TOWN OF BAY HARBOR ISLANDS MORRIS N. BROAD COMMUNITY CENTER

**DEVELOPMENT & REVIEW COMMITTEE MEETING
THURSDAY, MAY 9, 2024**

Subject: Site Development Plan Application - #1 Review & Comments
10150-10190 East Bay Harbor Drive & 1075 101 St. – 20 DU Townhouses
Bay Harbor Islands Acct. No. SPR2024-000011
MMPA Acct. No. 01-0702-1190

Date:	Sheet No.
Scale:	A1.00
Project: 2416

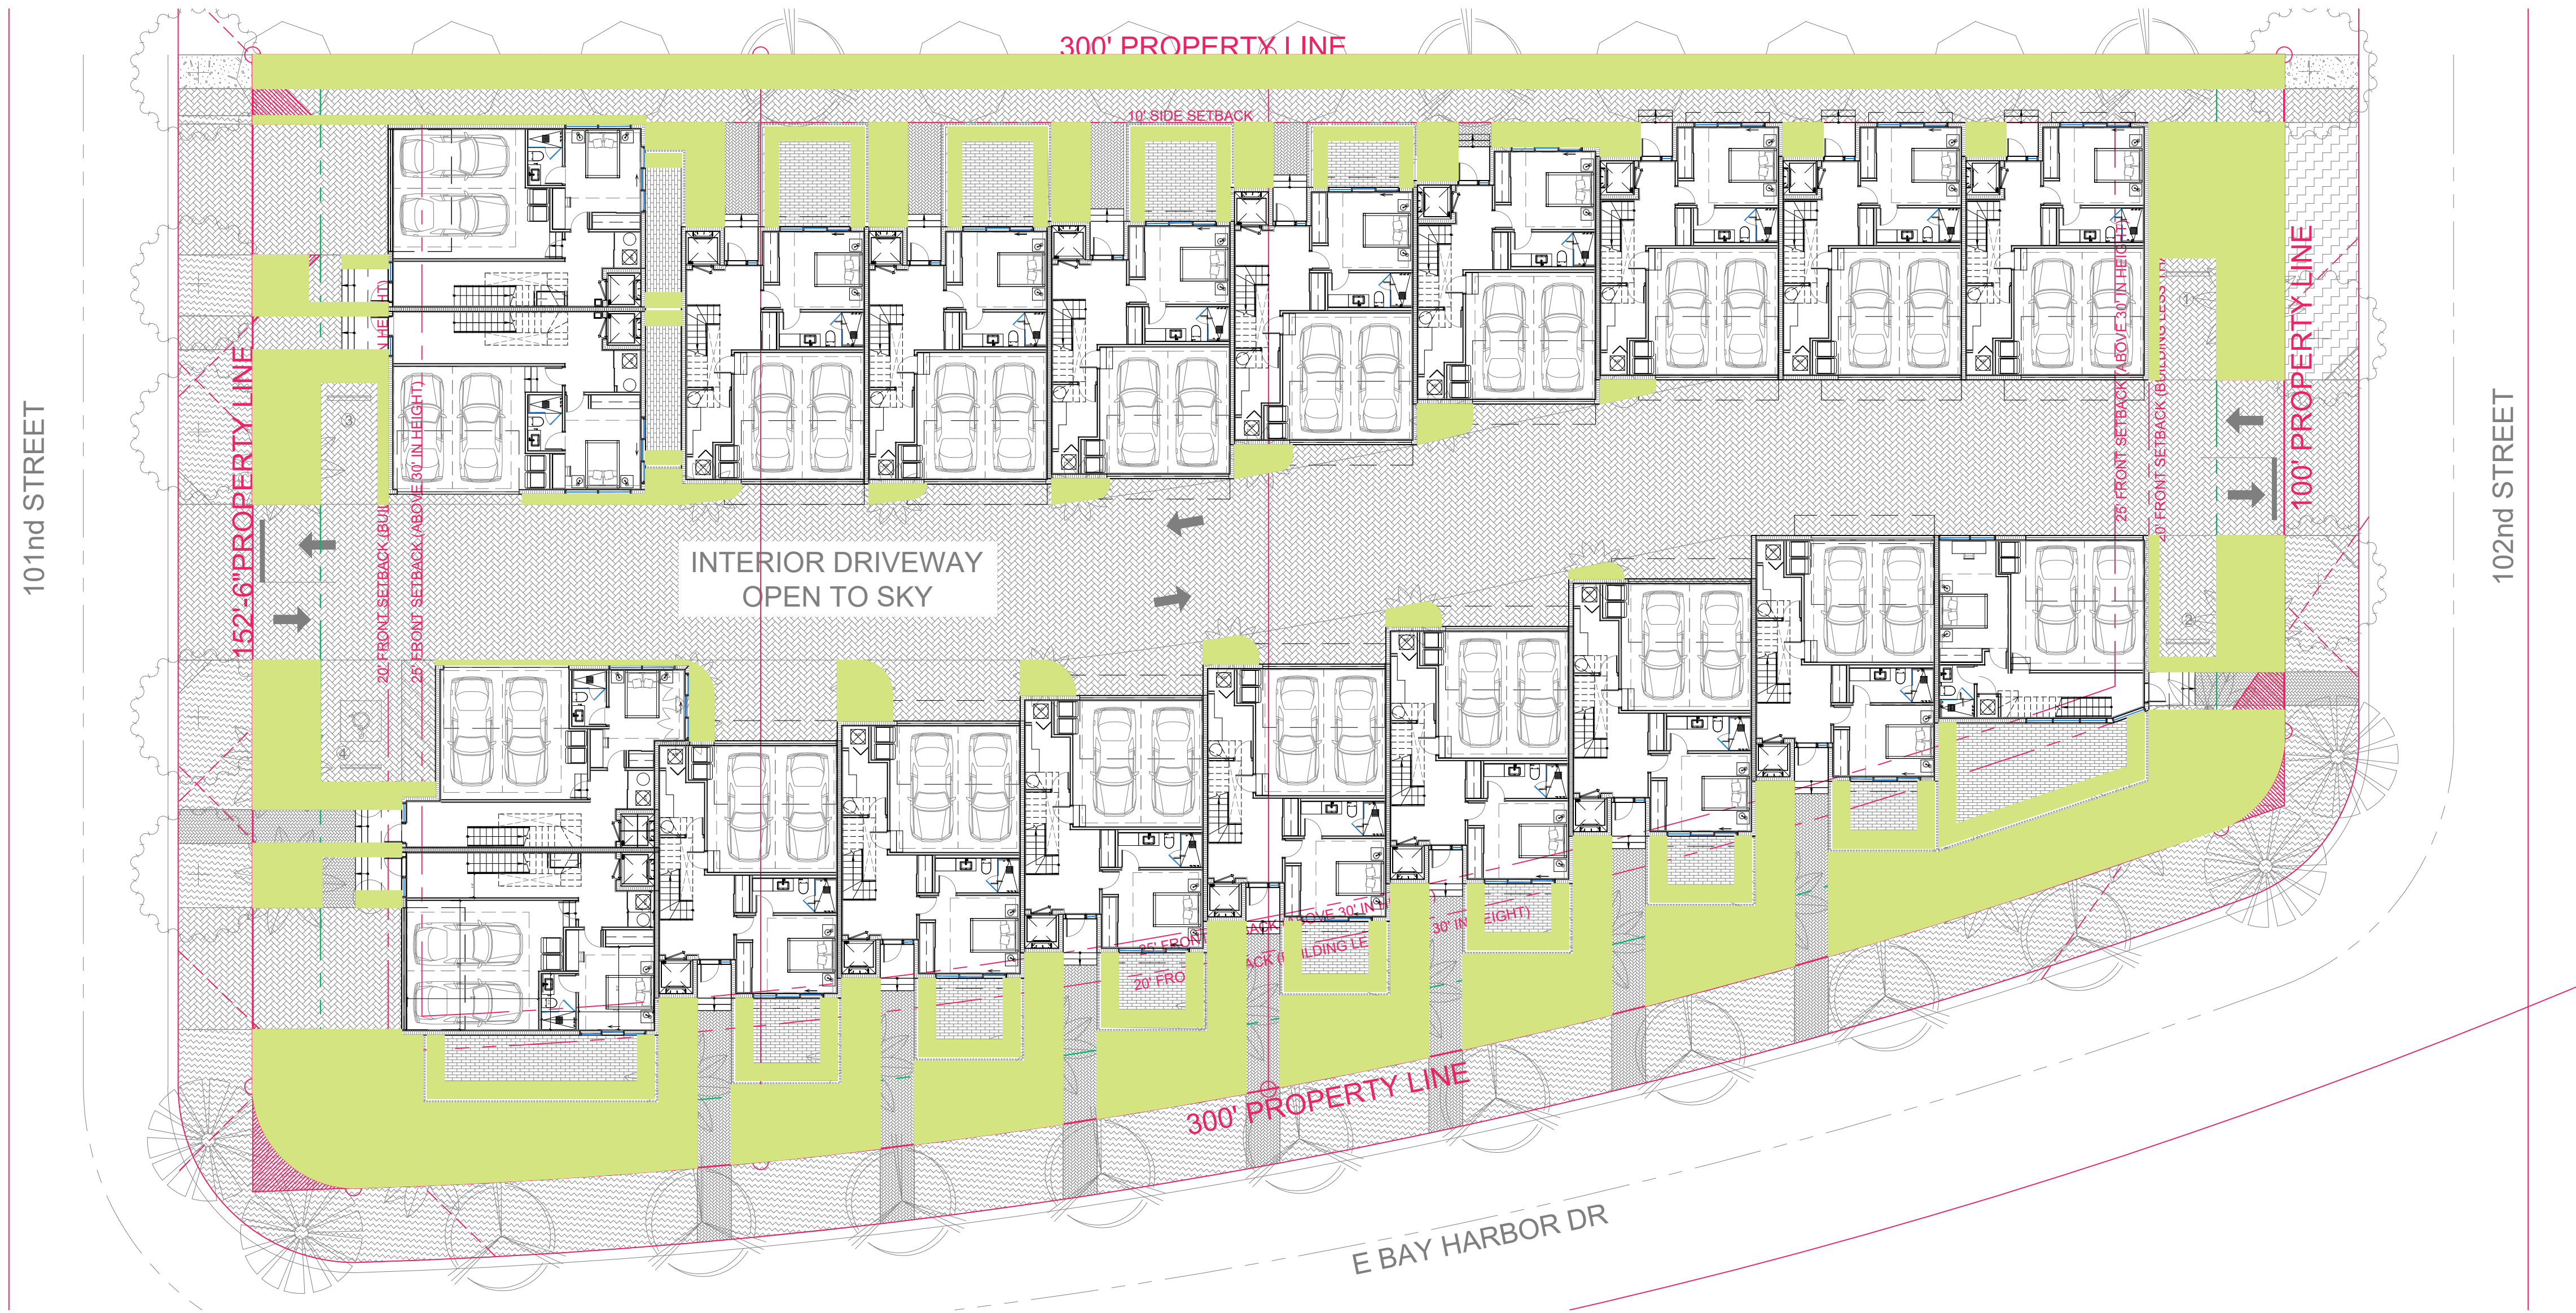
- 1) Sheet A1.00 Under Site Requirements – Lot Area include the property acreage in addition to the square footage. FYI – there seems to be a math error in the site size – 44,014 sq. ft. = 1.0104 acres. The plan shows 1.019 acres for density calculations = 35 DU allowed. However, $1.014 \times 34 = 34.35$ DU / rounded won to 34 DU allowed.

Date: _____ Sheet No. _____
Scale: _____ A2.00
Project: 2416

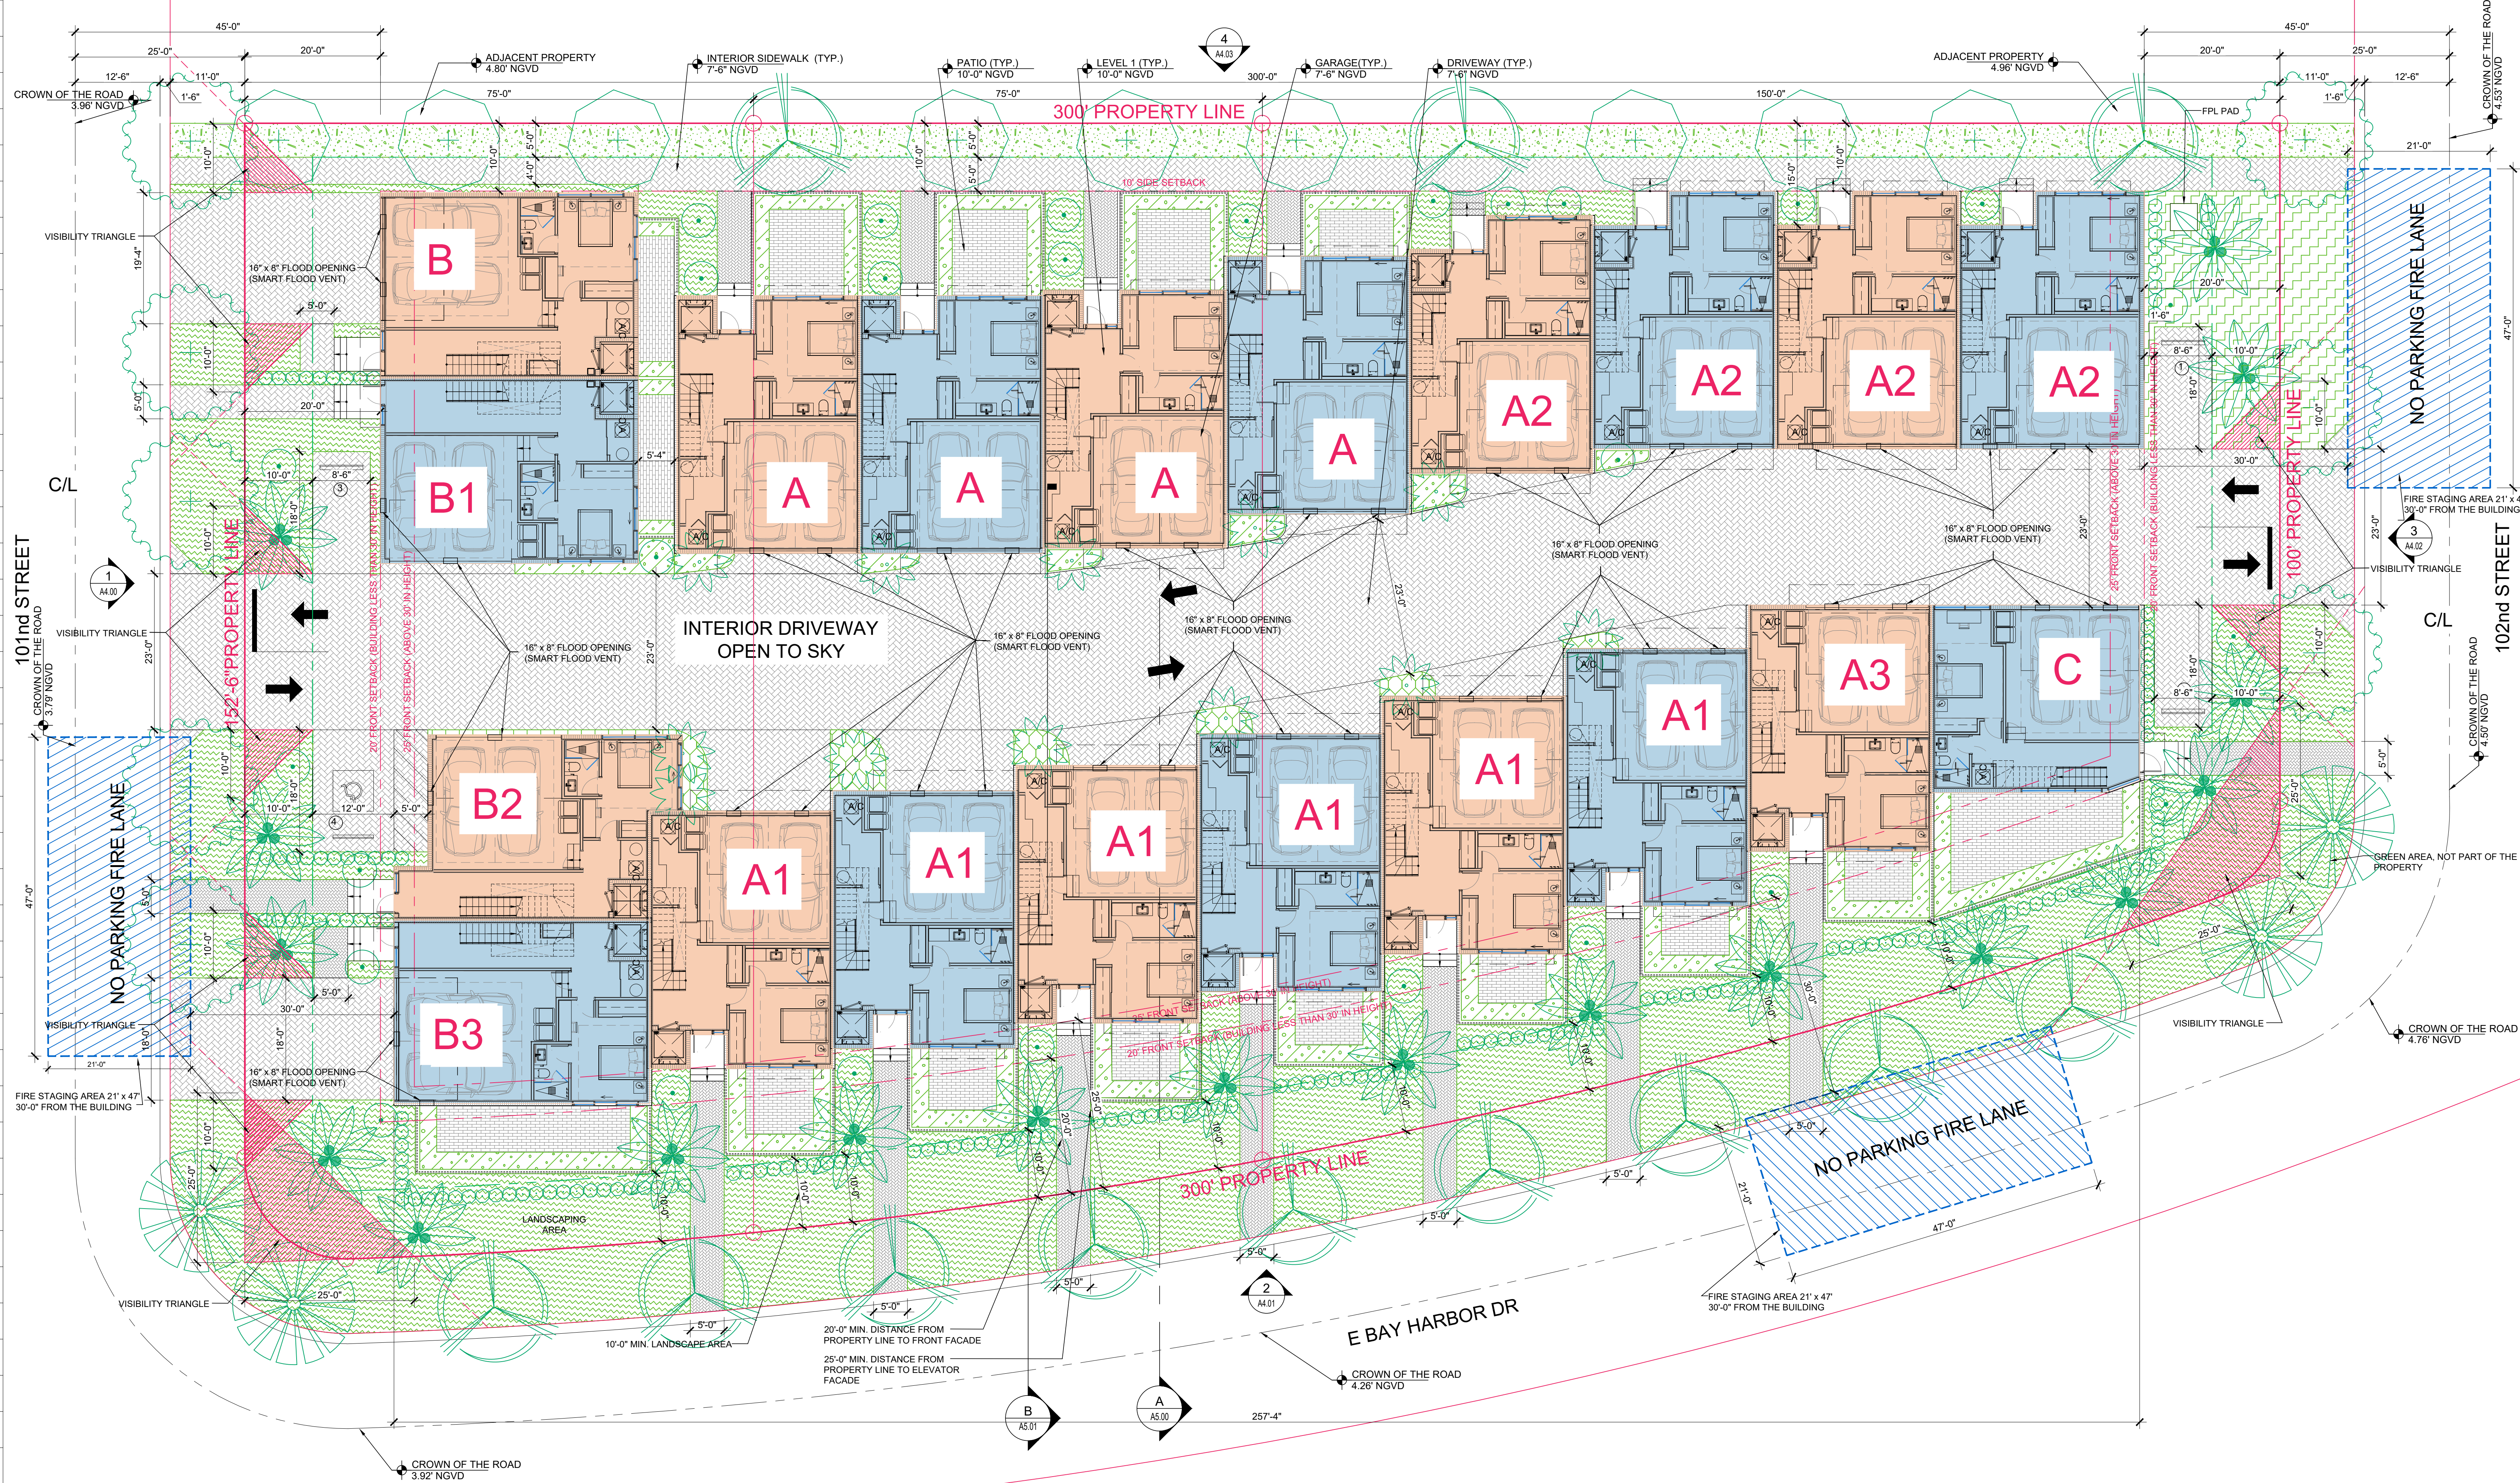
- 2) Sheet A2.00 has the following issues:
 - a. Please provide details including height, color and material of the proposed fence at the rear of the townhouse units.

- b. Please provide pavement markings and signage for the entrance driveway connections on 101st Street and 102nd Street.
 - c. Please provide boundary information on the plan based on the project survey.

Sheet Description
LANDSCAPE
PLAN

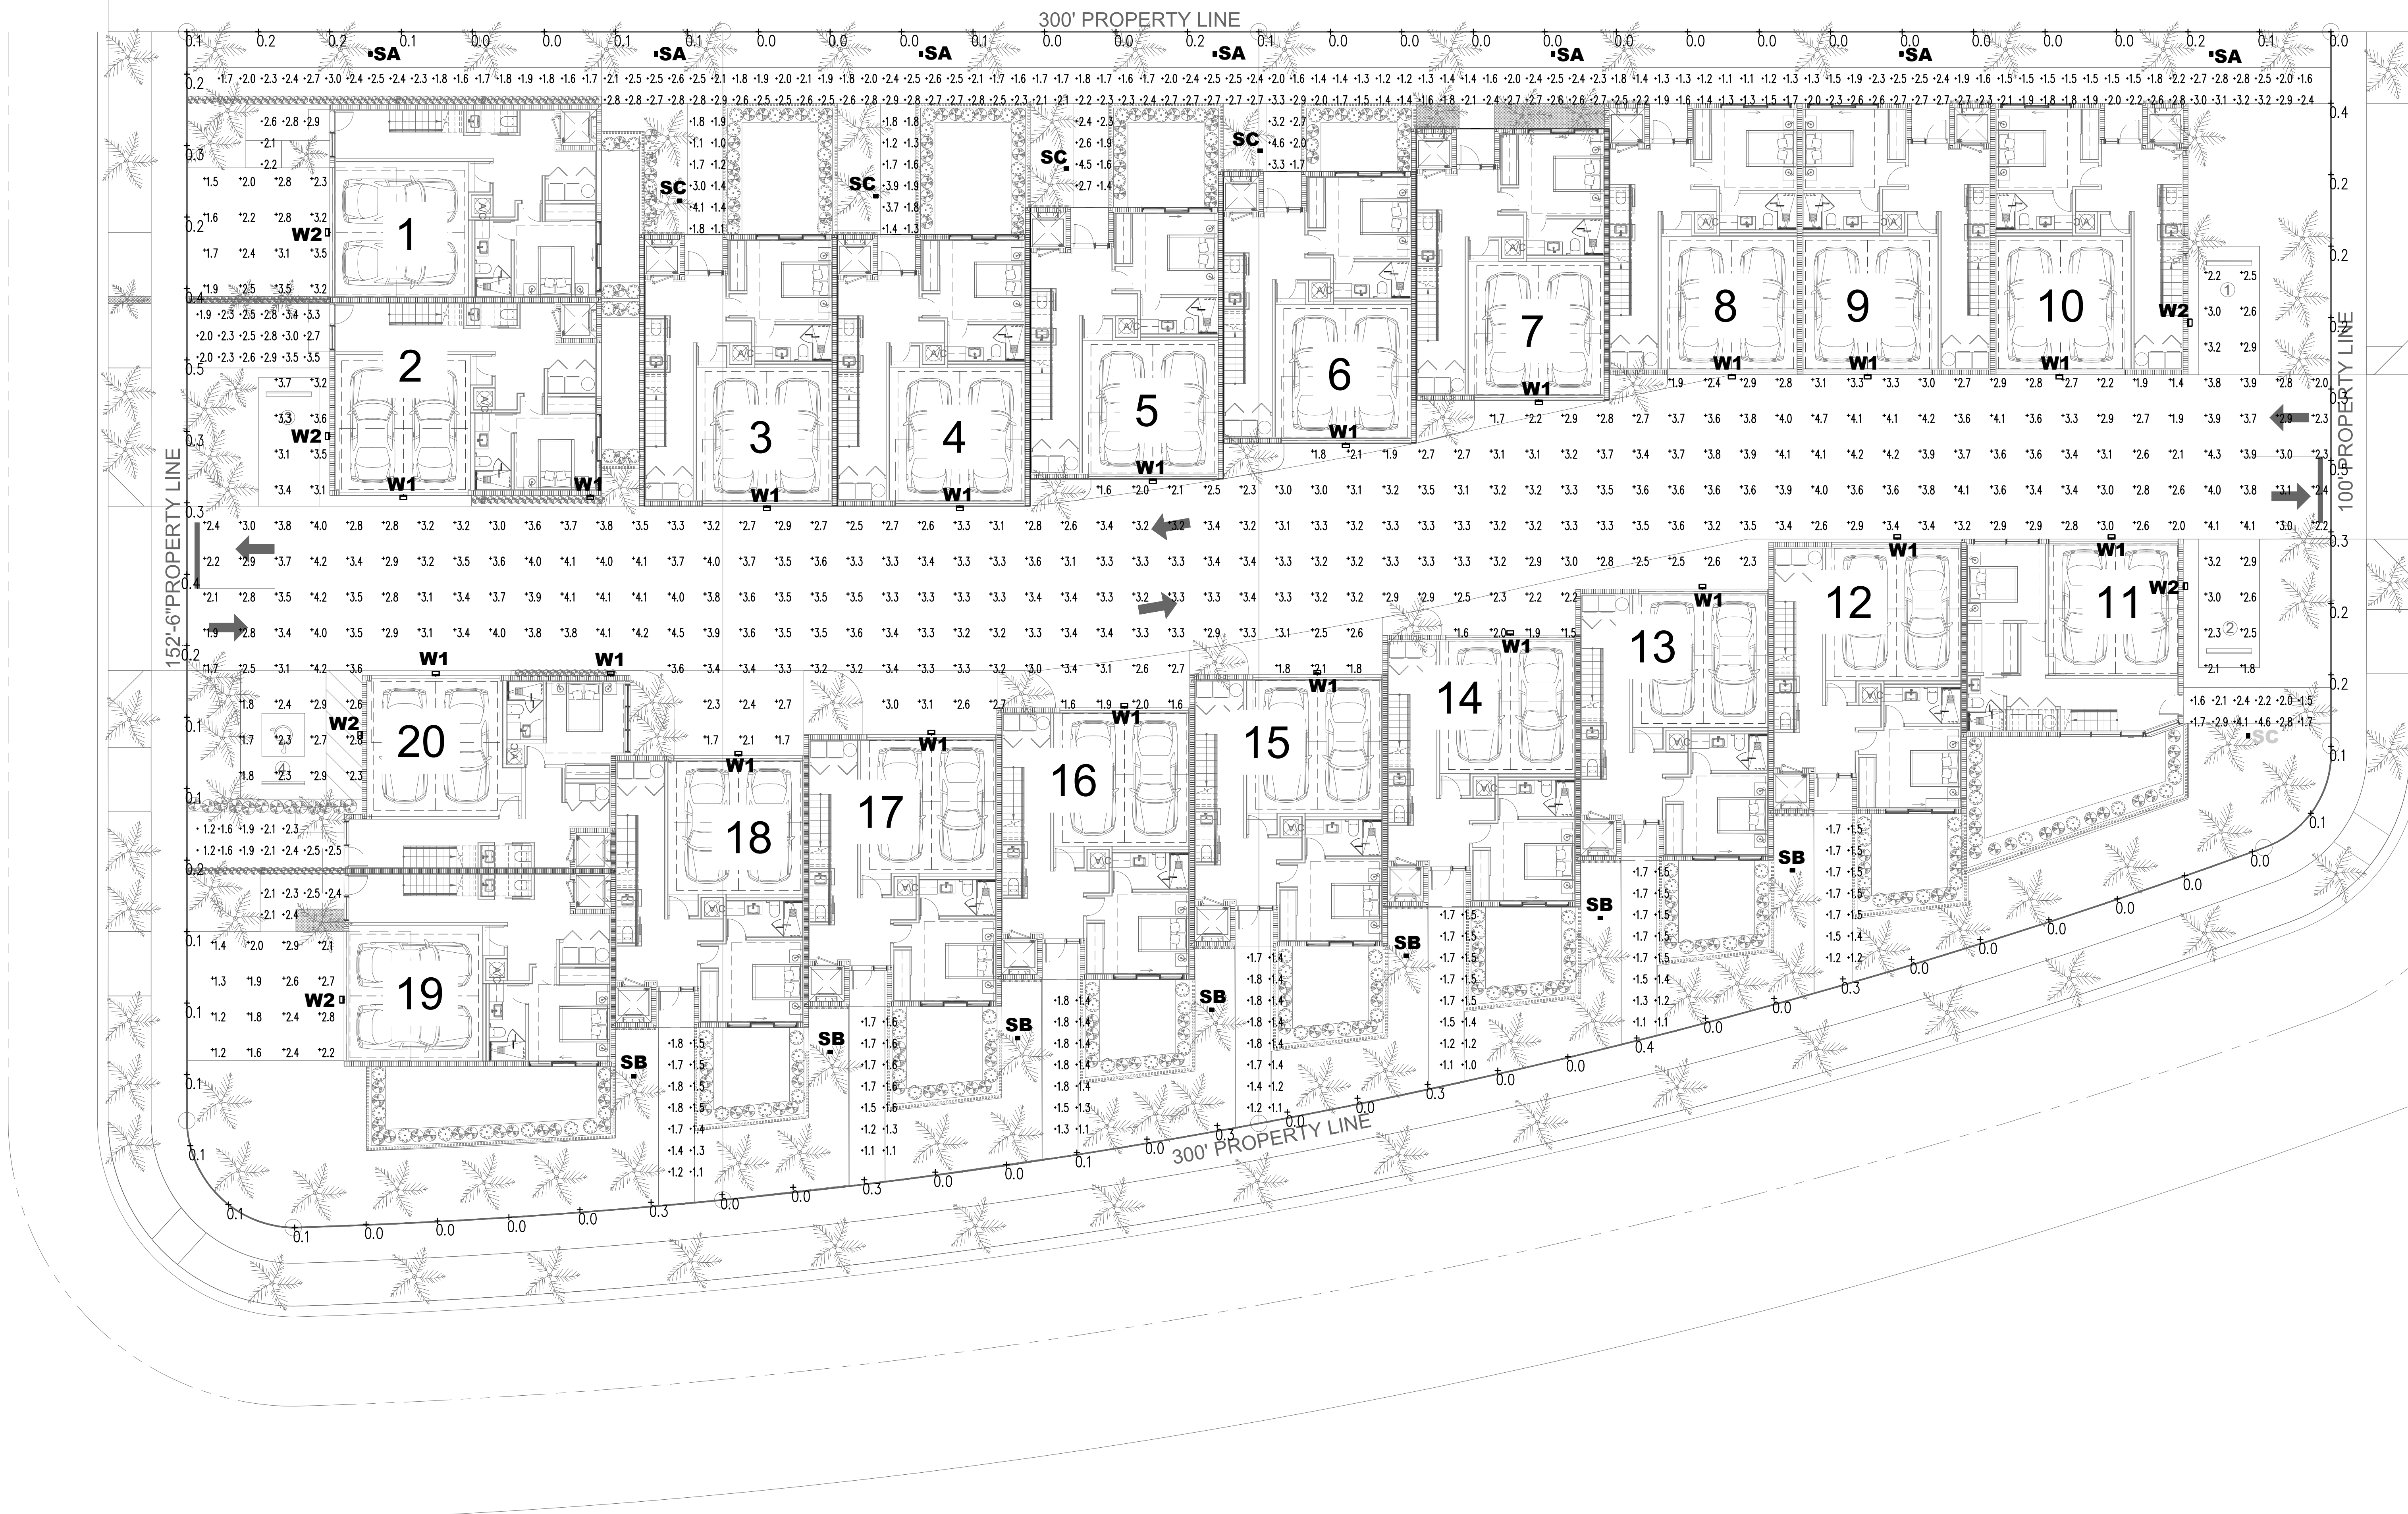
- b. In the Landscape Table on Sheet L-200 the Street Trees and Site Trees need to be broken apart for information / quantitative purposes.
 - c. Identify the type of irrigation system. A separate meter is recommended.
